**New Brunswick Power Corporation,
Point Lepreau Nuclear Generating Station**

Application for the renewal of NB Power's licence for the Point Lepreau Nuclear Generating Station

**JOINT SUBMISSION BY THE COALITION FOR RESPONSIBLE ENERGY
DEVELOPMENT IN NEW BRUNSWICK AND THE CANADIAN
ENVIRONMENTAL LAW ASSOCIATION TO THE CANADIAN NUCLEAR
SAFETY COMMISSION REGARDING THE RENEWAL OF THE POINT
LEPREAU NUCLEAR GENERATING STATION POWER REACTOR
OPERATING LICENCE**

Hearing Reference: 2022-H-02

Figure 1. Residual sea levels (with 5 to 95% uncertainty in grey) and associated return periods for Saint John⁸⁴

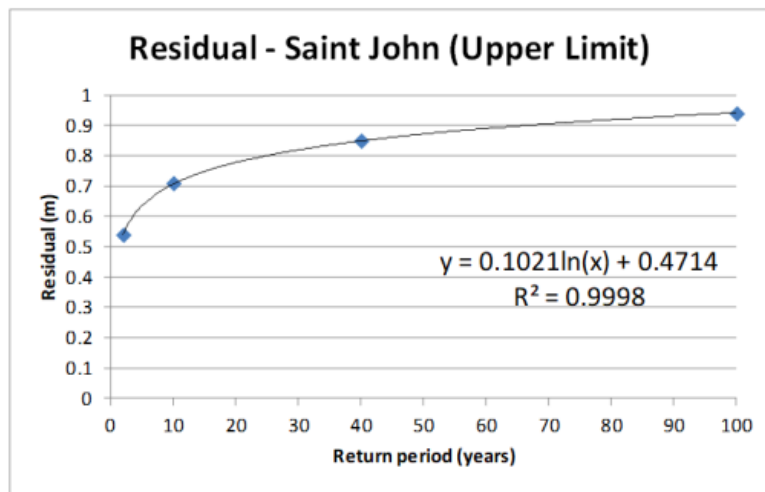
The intervenors submit that climate change poses unique dangers to Point Lepreau due to its location on the Bay of Fundy: because of climate change, high water in the Bay of Fundy is predicted to rise on the order of 0.5 m over the next 50 years, and on the order of 1 m by the end of the century.⁸² Sea level rise and flooding scenarios up to the year 2100 have been projected for coastal communities in New Brunswick, including Saint John and the Bay of Fundy region.⁸³

Therefore, the intervenors **submit** that site-specific climate change impacts and associated external events have to be assessed and used to set criteria for evaluation of the 25-year licence application.

Figure 2. Excerpt – Emergency response zones

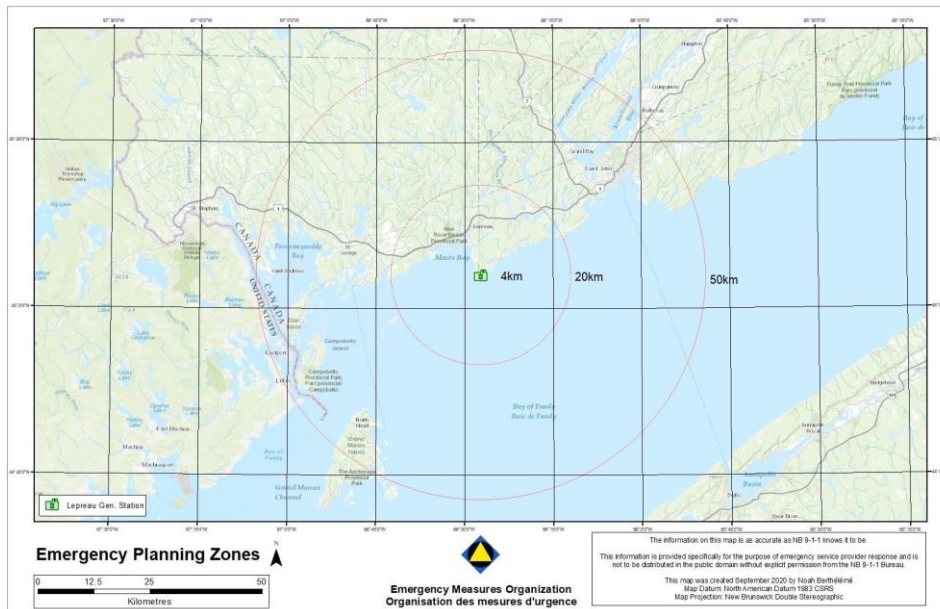
The intervenors submit that NB EMO’s Ingestion Pathway Zone does not align with international guidance (see Figure 2). Specifically, the IAEA recommends that for reactors of 1000 MW(th) or more, the Ingestion and Commodities Planning Distance ought to be 300km (see Figure 3). The corresponding Ingestion Planning Zone at Point Lepreau only extends to a distance of 57 km. As Point Lepreau has a thermal capacity of 2180 MW(th),⁹² the IPZ must be extended to 300 km and include the additional requirement that all municipalities within this zone maintain nuclear emergency response plans.

Recommendation No. 27: To conform with international guidance, the Ingestion Pathway Zone must be expanded from 57 km to 300 km and include the additional requirement that all municipalities within this zone maintain nuclear emergency response plans.
